Proposal
Erection of 12 town houses

Address
Plots 13, 19, 25 & 31
Gourdie Street
Dundee

Proposed Housing Development in Gourdie Street

The erection of 12 town houses is **RECOMMENDED FOR REFUSAL**. Report by Director of Planning and Transportation

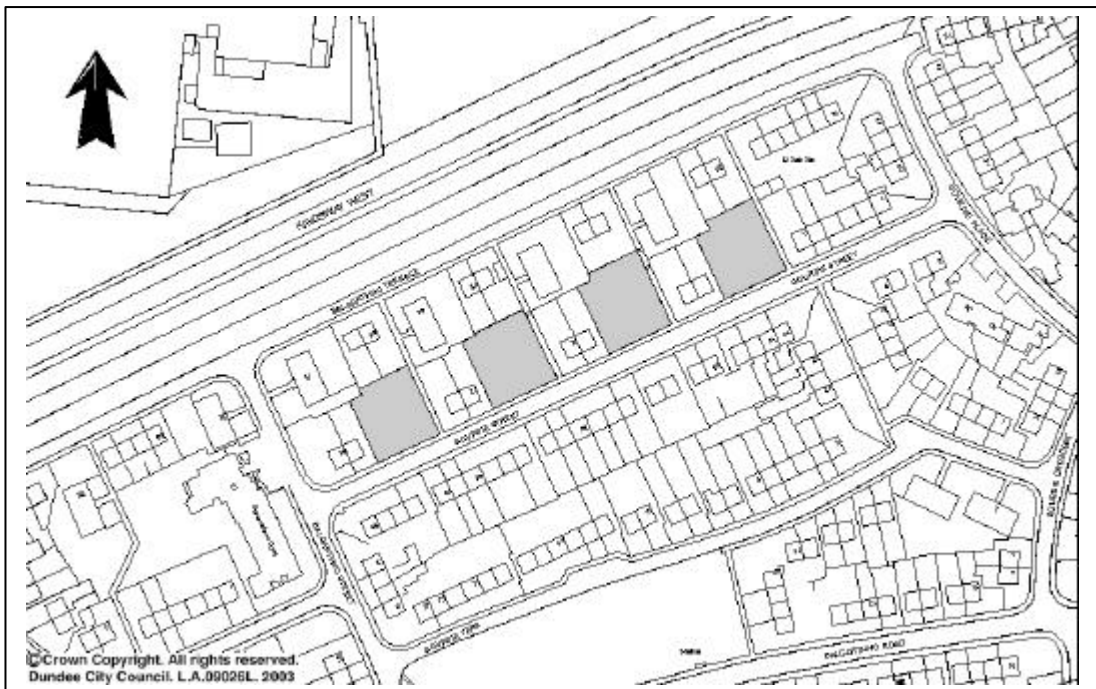
In terms of car parking provision, each house would have an integral garage and a driveway in front of the house. It is intended that the driveway would be used as a parking space. As originally submitted, the driveways would measure only 4.2 metres in length from the back edge of the road. At such a short distance the driveways would not meet the minimum requirements for a car parking space. It would not be possible to open the garage door with a car parked on the driveway without the end of the car overhanging the road. This would be unacceptable in road safety terms.

However, amended plans were submitted showing the driveways extended to 5 metres in length, and the garages having roller shutter doors. Appropriate provision has also been made for some properties to have 2 off street spaces in addition to the integral garage. Therefore the proposal complies with the car parking requirements of Policy 4 of the Dundee Local Plan Review 2005.

Policy 4 requires that a minimum of 120 sq. m. of useable garden ground is provided for each house. None of the proposed houses would have useable garden ground of at least 120 sq. m. The largest garden area would be below 100 sq. m. Consequently the proposal is contrary to the provisions of Policy 4.

The proposal does not provide the minimum of 120 sq. m. useable garden ground for each new house. Consequently the proposal is contrary to the provisions of Policy 4 of the Dundee Local Plan Review 2005.
